## ITASCA DOCUMENT REVIEW

Document: "The State of In-Situ Stresses Determined by Hydraulic Fracturing at the Hanford Site" by Kunsoo Kim, Steven A. Dischler, James K. Aggson, and Michael P. Hardy (RHO-BW-ST-73P)

Reviewer: Itasca Consulting Group, Inc.  
(M. Board)

Date Review Completed: 25 July 1986

Fig. 1 Seismicity in the Pasco Basin as Determined from the Site Monitoring System

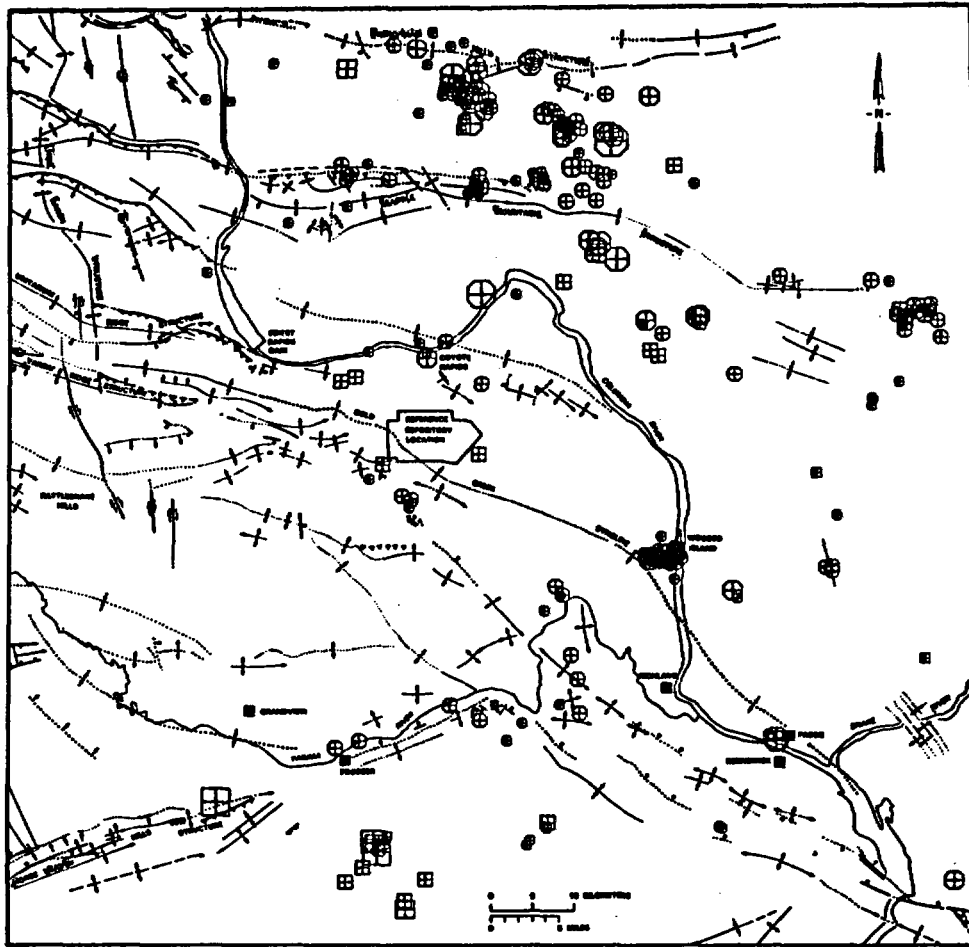
As a rock mass undergoes yield, seismic energy is released. The rate and magnitude of these releases are indicators of the intensity of the applied stress field. Seismicity at the Hanford site is characterized by shallow microearthquake "swarms" consisting of up to 100 earthquakes of magnitude 1 to 3.5. These swarms typically last a few days to several months and occur within a rock volume roughly 5km on a side. About 75% of all microearthquakes occur at depths of less than 4,000m. Figure 1 shows the location of swarm activity, which is greatest in the Saddle Mountains and Frenchman Hills structures as well as Wooded Island at the eastern boundary of the site. Focal mechanisms indicate a major north-south horizontal compression with a vertical minimum compression. This is consistent with east-west trending fold axes and sub-parallel thrust or reverse faulting.

Fig. 2 Illustration of Hydraulic Fracturing Terminology  
(In the present case,  $P_o \approx P_h$ .)

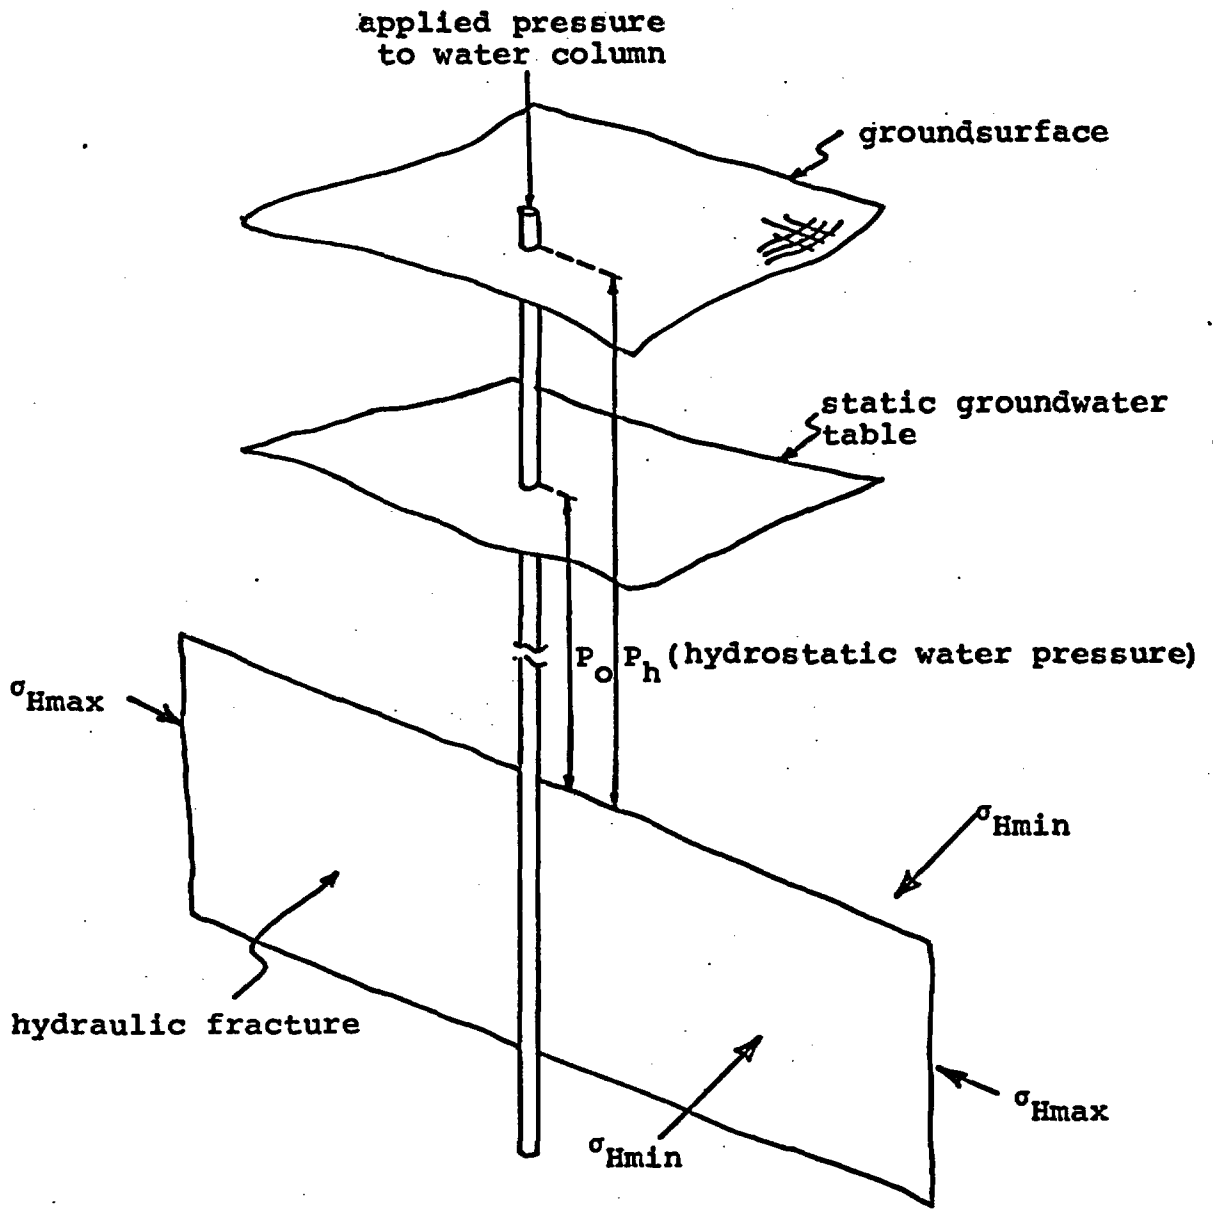
Figure 2 is a schematic which illustrates these quantities. In a crystalline rock with low permeability, it is questionable whether communication between fracture and the water pressure is established. The conservative assumption is that the pore pressure term be neglected from the above equation. The authors argue that the pore pressure be included in the analysis, citing work by Hickman and Zoback (1982) as supporting their position. Although we agree in principle with this approach, it is felt that, for re-

pository design, the most conservative method (i.e., zero pore pressure) should be chosen.

Fig. 3: (a) Horizontal Stresses as a Function of Depth  
(b) Stress Ratios as a Function of Depth

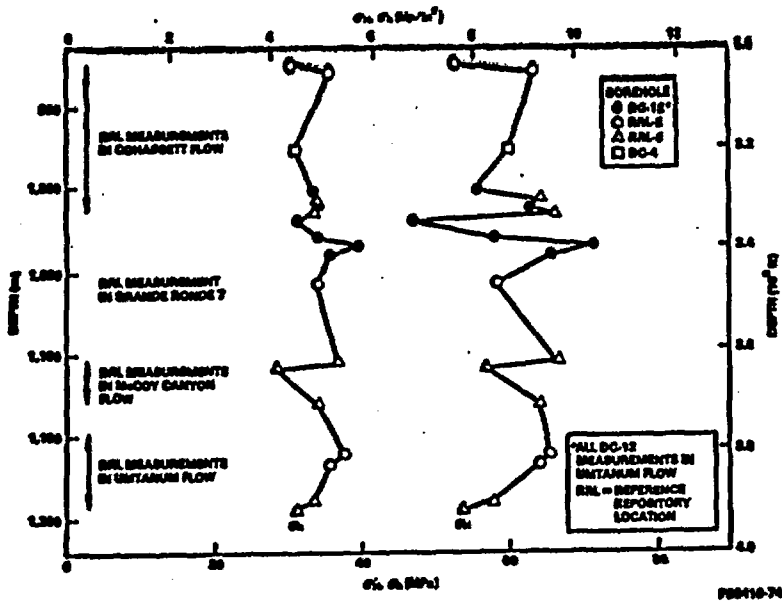
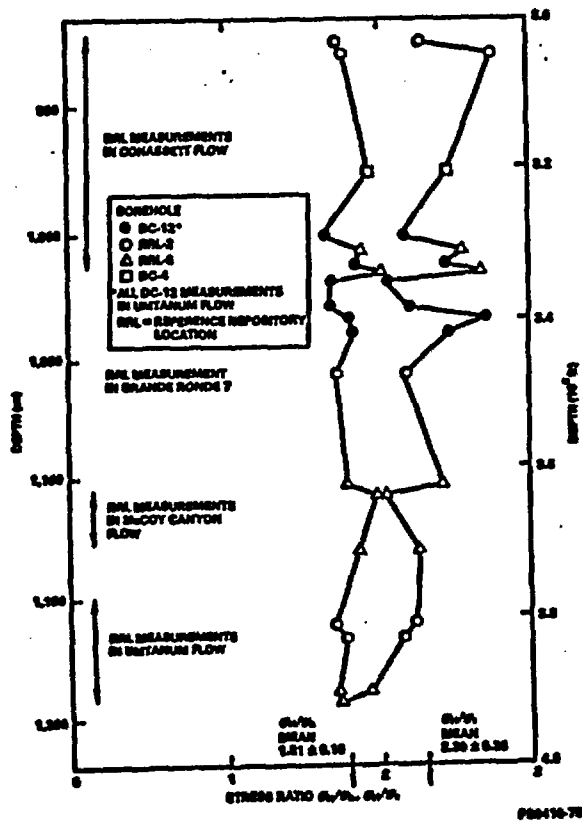
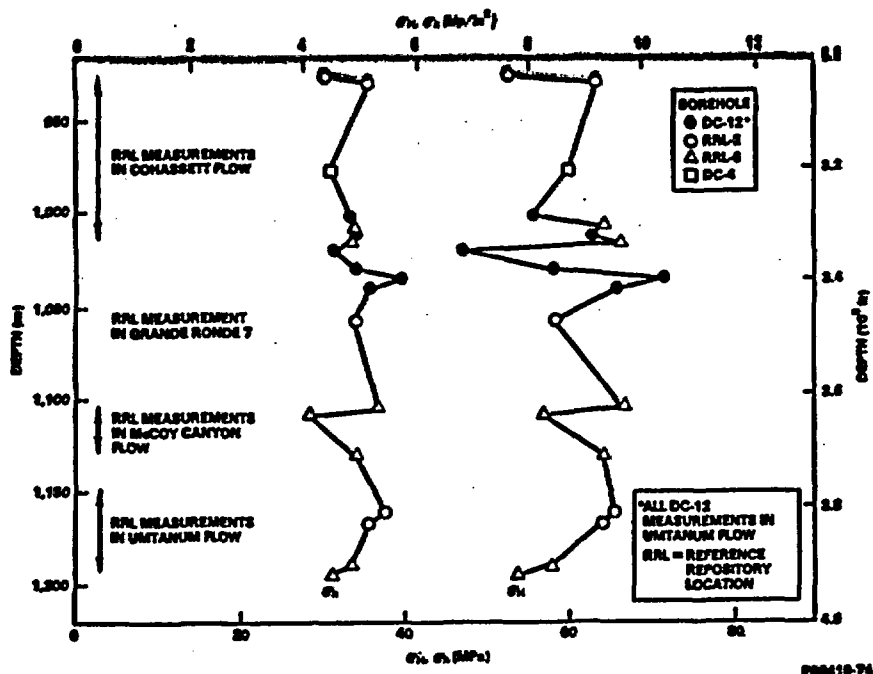
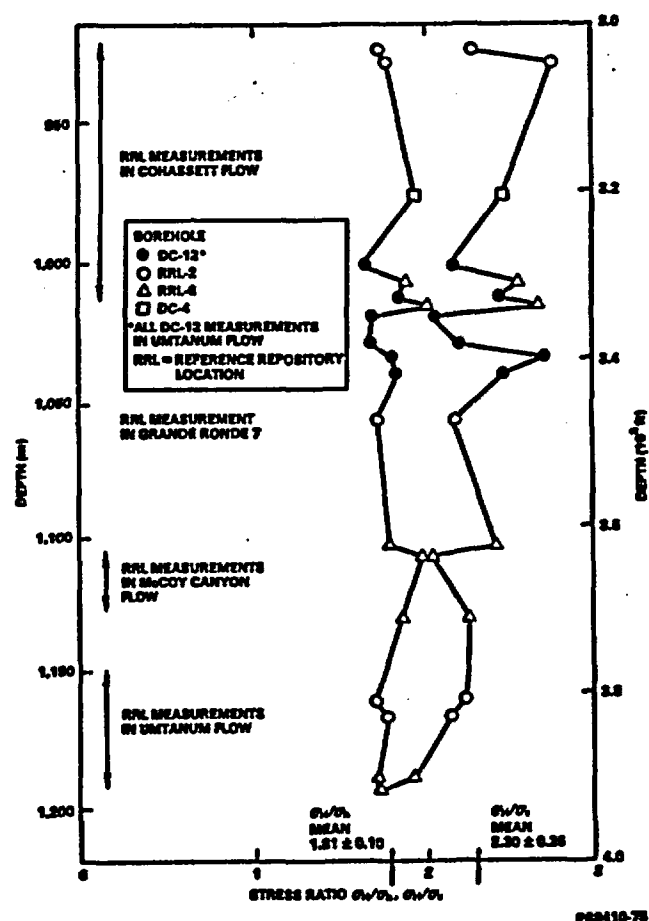
1. There is no consistent change in horizontal stress with depth nor is there a consistent change in stress ratio with depth (Fig. 3). It appears that any variation with depth is masked by scatter in the data.
2. Measurements of horizontal stress from the Umtanum Flow within and outside the RRL indicate little lateral variation in stress; however, there is too little data to make this assertion confidently. It is reasonable to assume that the stresses are consistent laterally within the RRL.
3. The data consistently indicates a north-south major horizontal compression. This correlates well with geologic data discussed earlier.

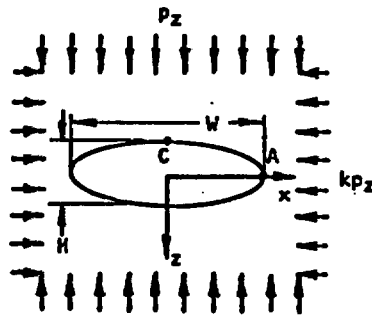
The effect of these higher design stresses can be seen by examining the stress concentrations around the emplacement room periphery. If it is assumed that the emplacement room is an ellipse, effects of these new stresses can be easily examined from an analytic solution. Hoek and Brown (1980) give the solution for the tangential stresses at the boundary of an ellipse in a bi-axial stress field:

The stress at the roof is now nearly at the design criteria without addition of thermal loads.

Fig. 4 Mohr Envelope Plot of Stress States Given in Table 4

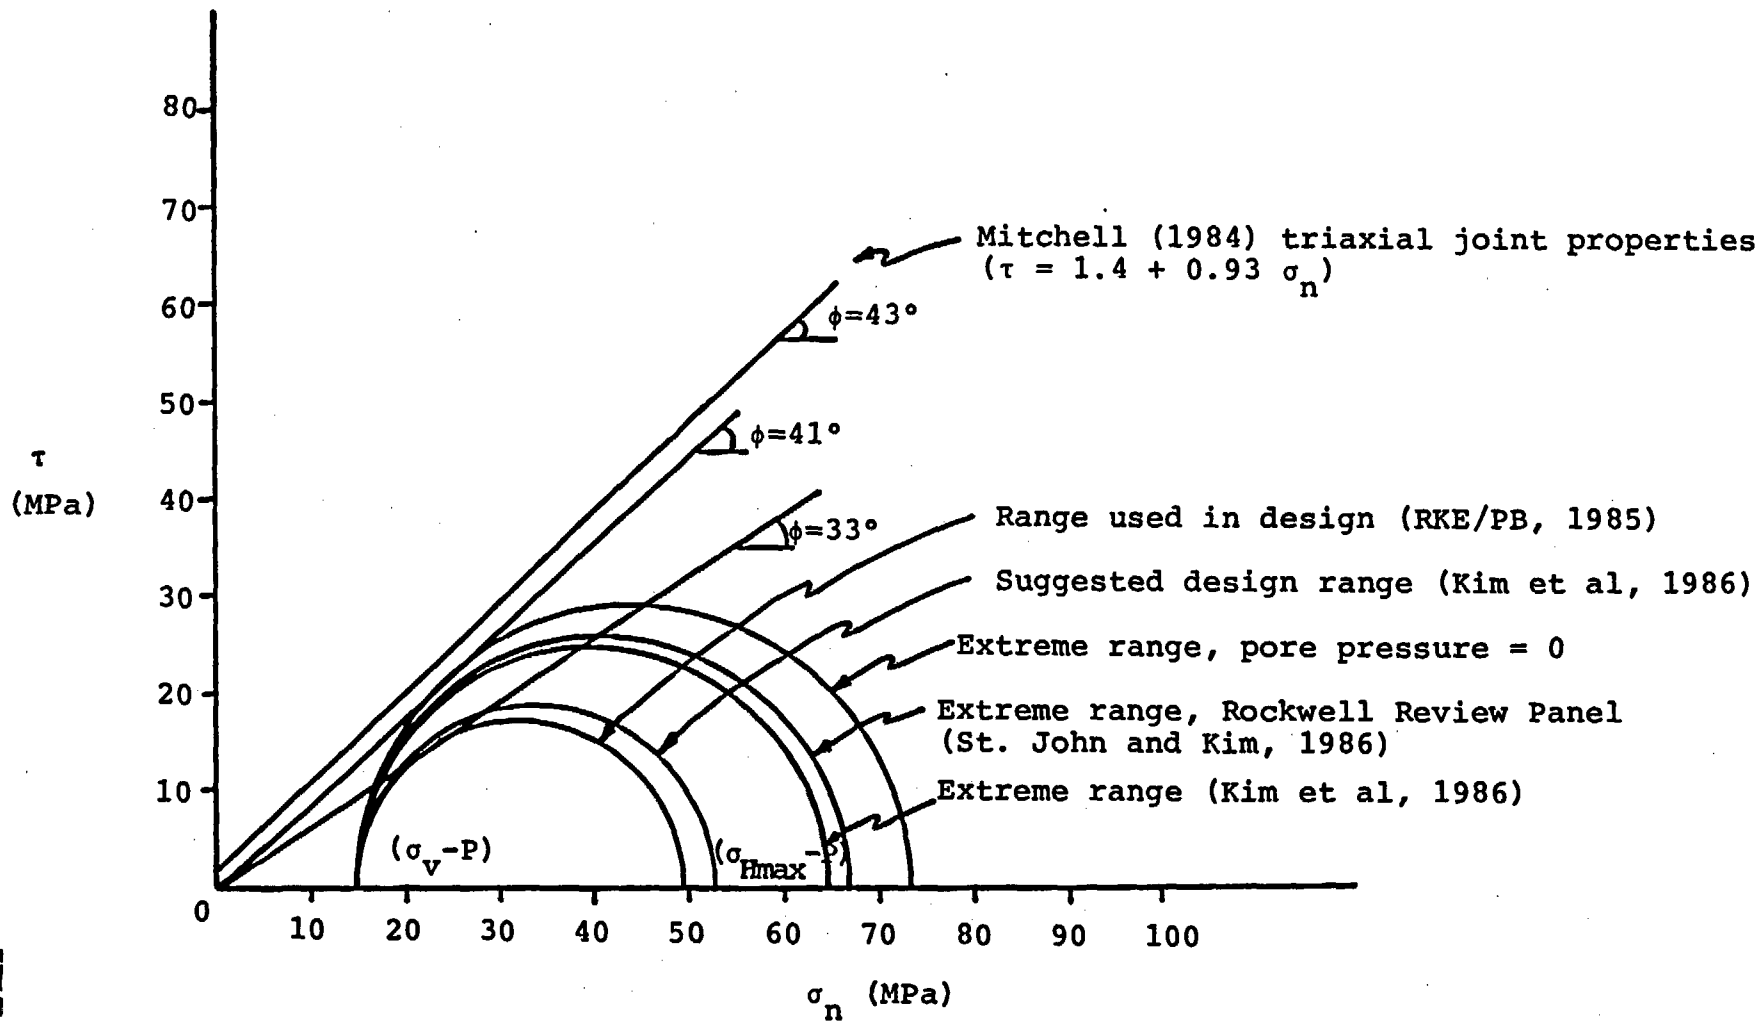
The analysis of possible fault or joint slippage under the influence of the in-situ stresses presented on pp. 57-59 must also be examined in the light of the extreme data ranges. This analysis indicates that in-situ joint friction would have to be as low as 33° (with no cohesive strength) for slip to occur. It is suggested that microseismic events at the site are related to small areas of joints where the friction angle is low or at joint intersections. A plot of the Mohr envelopes for the extreme data ranges is given in Fig. 4. Here, the range of extreme values for the  $\sigma_{Hmax}, \sigma_y$  envelope are plotted for all stress values discussed in this review. As seen, the ranges of stress recommended by Kim et al (1986), the review panel, and this review are fairly similar and suggest slip on surfaces with a friction angle of about 40° for cohesive joints.

(This plot shows that for the extreme stress states, slip could occur on favorably-oriented joints with friction angles of  $40^\circ \pm$ .)
